RE: Schneipp 2nd Addition
Drainage Concept

STAFF REPORT
(One-Step Final Plat)

CASE NUMBER: SUB 2000-53 -- SCHNIEPP 2ND ADDITION

VICINITY MAP

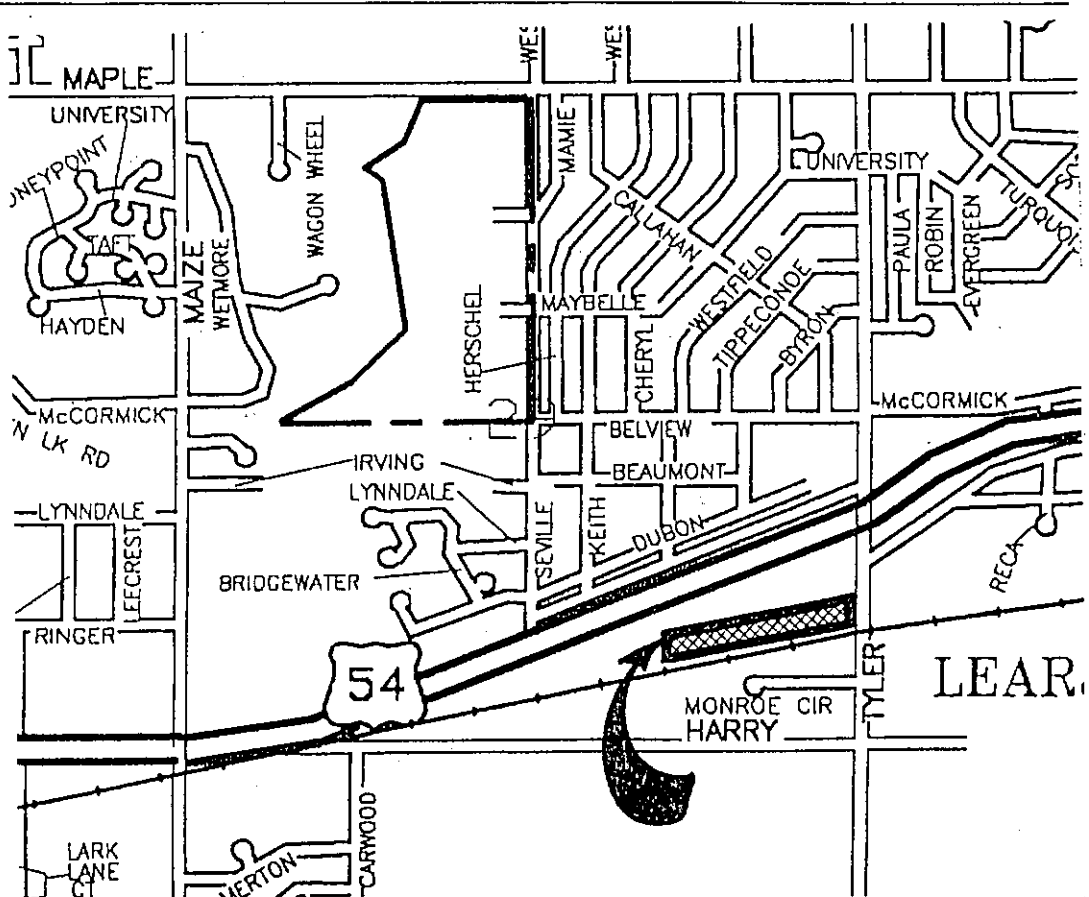
*Need to ext SS
off-site drainage
agreement*
